**RE: Cypress Woods RV Resort PD
DCI2020-00002**

Enclosed please find responses to Staff's comments dated May 17, 2020. The following information has been provided to assist in your review of the petition:

CYPRESS WOODS RV RESORT PHASE 5 RECREATIONAL VEHICLE PLANNED DEVELOPMENT

MASTER CONCEPT PLAN

NOTES:

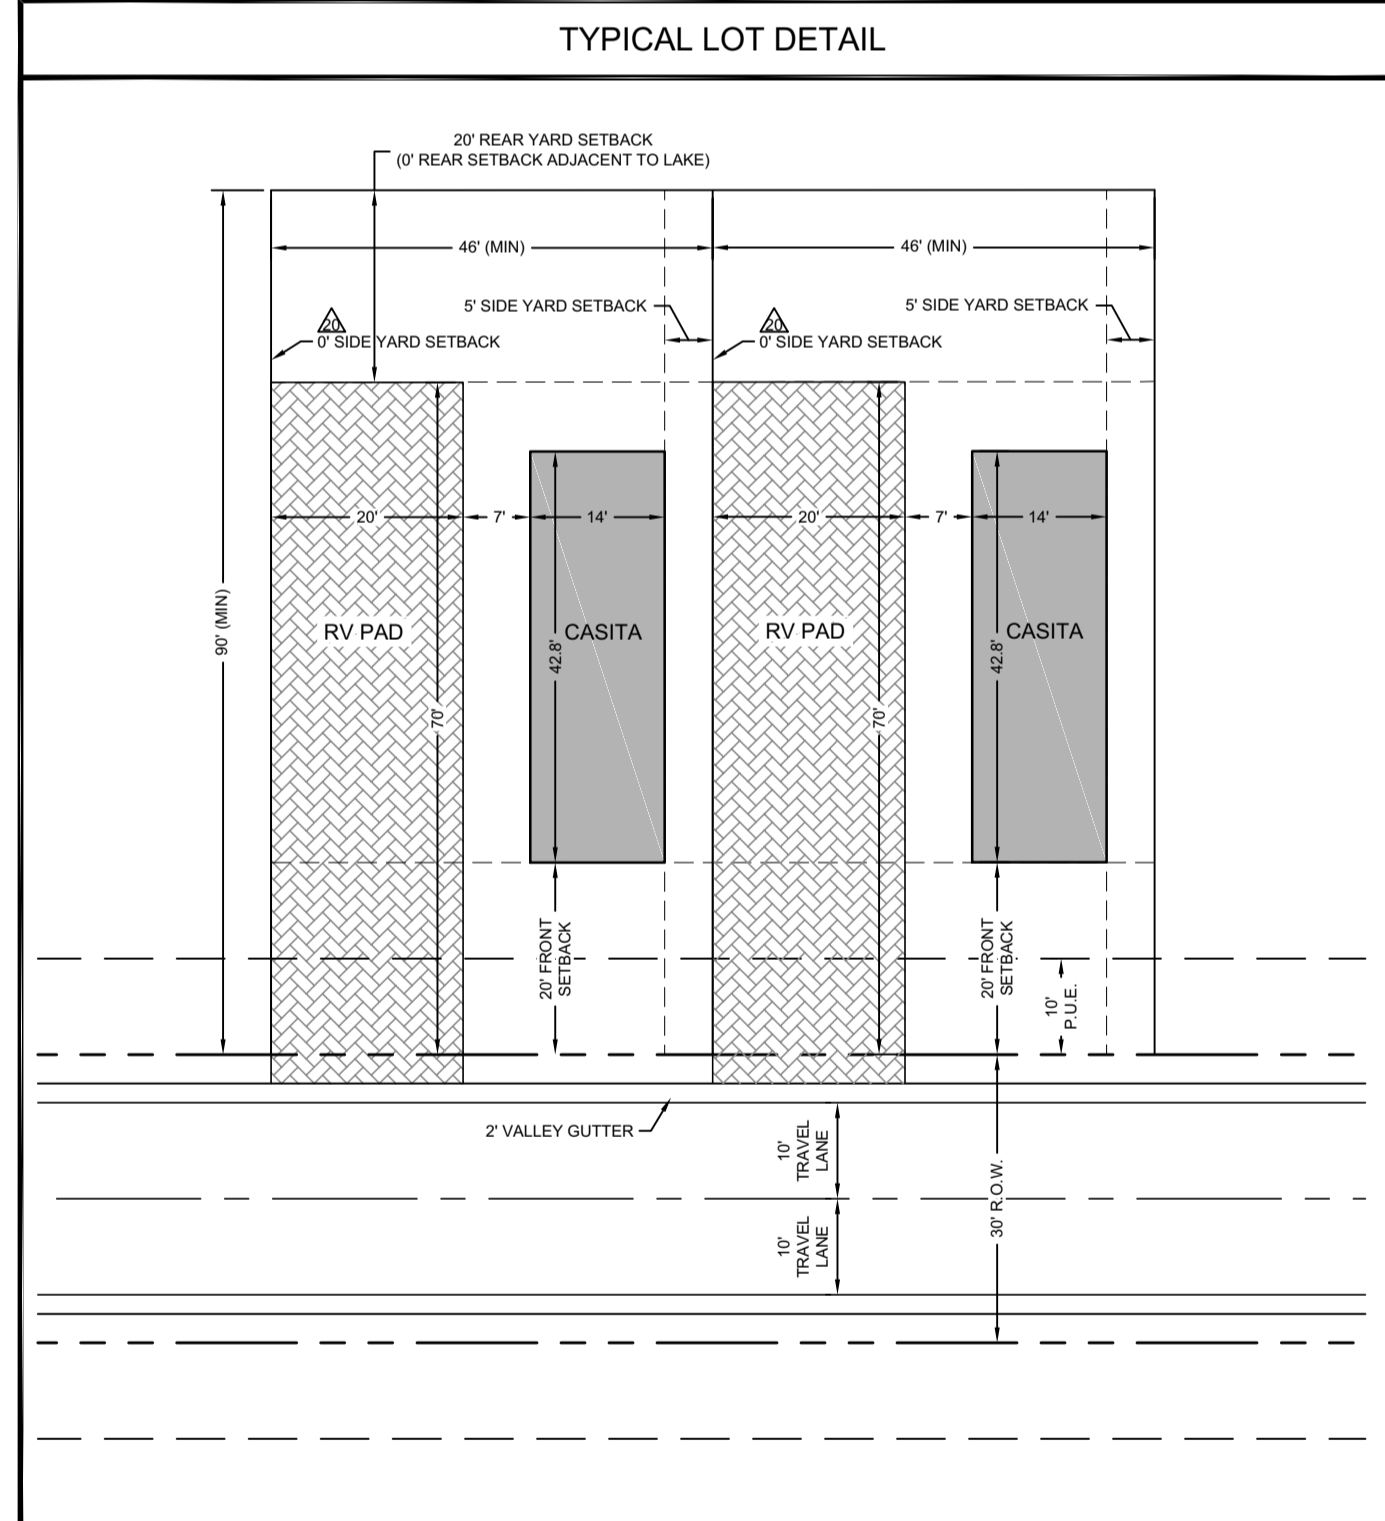
1. The applicant's justification doesn't address the single family residences zoned AG-2 to the NE which will have an unobstructed view of open storage, pickle ball courts and dog park. Additionally, the lots to the north will also have an unobstructed view. Please address the issue of off-site impacts caused by having no buffer and provide additional justification or measures to mitigate this concern.

- Deviation #21 must include a visual screen. LDC 939(b)(3) requires a 40-foot wide buffer around the entire boundary of the property and does not minimize or eliminate the buffer based on the abutting use. County staff will not approve no buffer for the accessory uses proposed along the north and northeast property lines. There must be a visual screen located outside of the FPL easement.

RESPONSE: Please refer to the revised Master Concept Plan attached. A 6' tall double hedge row has been provided on the east side of the FPL easement to provide a visual screen of the proposed recreational uses and storage area. Please note this area will not be used for RV storage. The intent is to store vehicle trailers and similar items. Thus, the 6' tall screen will adequate block views of the items stored.

RESPONSE: Please refer to the revised Master Concept Plan attached. A 6' tall double hedge row has been provided on the east side of the FPL easement to provide a visual screen of the proposed recreational uses and storage area. As noted above, this area will not be used for RV storage. The intent is to store vehicle trailers and similar items. Thus, the 6' tall screen will adequately block views of the items stored.

2. Please clarify deviation #3 call out as it is shown in the ROW in several locations on the MCP. The deviation refers to a turn out radius but is shown in areas where it would not be applicable.

RESPONSE: Please refer to the revised Master Concept Plan. References to Deviation 3 have been removed.

- Revise the MCP to state that a 40-foot buffer around the entire perimeter, excluding perimeter boundaries that abut adjacent RVPD or RV zoned property. Currently, the eastern property line states that a buffer is not required and is not in compliance with LDC 34-939(b)(3).

RESPONSE: The eastern buffer has been revised to depict the location where the RVPD 40-foot buffer is provided, and where the alternative screening is proposed per Deviation 21.

- The indigenous open space credit chart depicts wetland habitat being calculated for credit. LDC 10-415(b) only allows indigenous credit for uplands. Please see applicant's FLUCCS map versus the indigenous credit hatching. Revise indigenous open space credit chart and ensure open space is being met in accordance with Z-11-021.

RESPONSE: The table on MCP Sheet 4 is applicable to the overall RVPD and replicates the credits approved as part of Z-11-021 for Phases 1 through 4. No changes to the preserve acreages and credits for Phases 1-4 is proposed.

The Table has been updated for Phase 5 indigenous acreages only. The table demonstrates the proposed reduction in preserve area within Phase 5 of 1.8 acres of actual preserve. Per footnote 1 under the table, the acreages reflect revisions within the Phase 5 Development boundary, and also corrects calculation errors in the previously approved MCP. Footnote 2 further clarifies that the Applicant is not seeking indigenous credit for any preserve areas in Phase 5.

The proposed indigenous acreage still exceeds the minimum required preserve acreage for the overall RVPD by 4.79 acres (30.3 acres required vs. 35.09 acres provided).
